KHNP Input Regarding RAI 252-8299, Question 03.07.02-7

1. Slab Modeling in RCB Structural Analysis Model

Figure 1 Comparison of Secondary Shield Wall ISRS, EL. 114'-0"

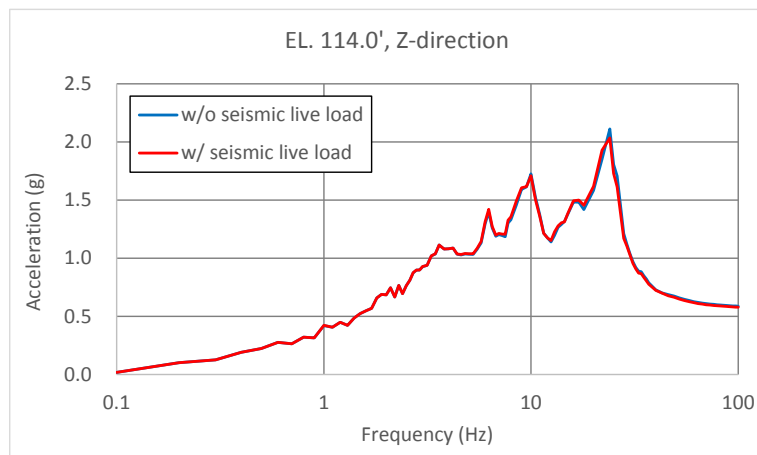
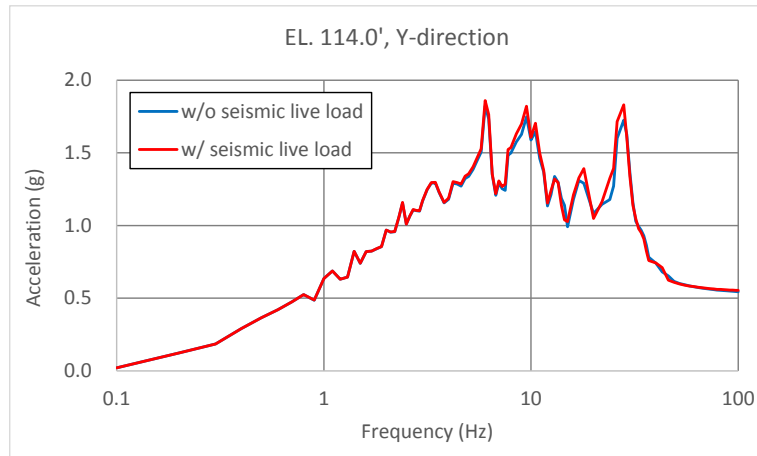
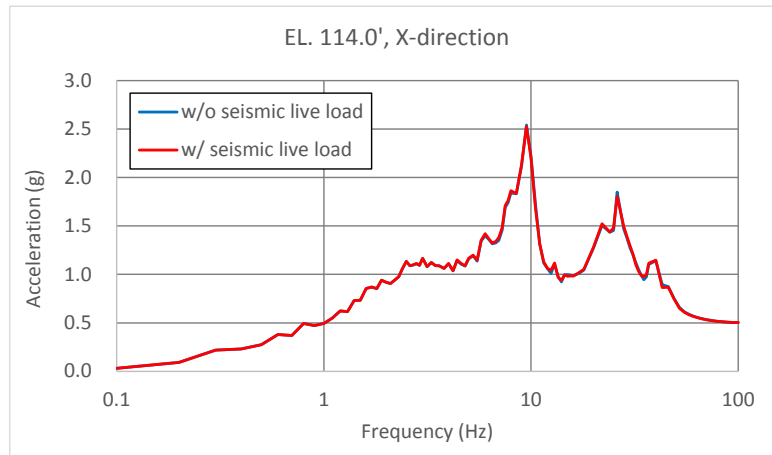
For evaluation of the effect of seismic live load on the seismic response of the secondary shield walls, the transient time history analyses are performed with fixed-base condition using two ANSYS models. One is original reactor containment building ANSYS coarse model, and the other is modified model considering the seismic live load. The masses equivalent to the seismic live loads which are applied to the slabs at EL. 114'-0", 136'-6", and 156'-0" of the reactor containment building are added to the secondary shield walls of the modified model. Then, the 4%-damped ISRS of secondary shield wall are compared between two models as presented in Figures 1 through 3. The nodes used in envelopment of the APR1400 ISRS of the secondary shield wall are identically used to generate enveloped ISRS for comparison. As shown in the comparison figures, the variation of ISRS due to the consideration of the seismic live load in containment building seismic analysis model is negligibly small.
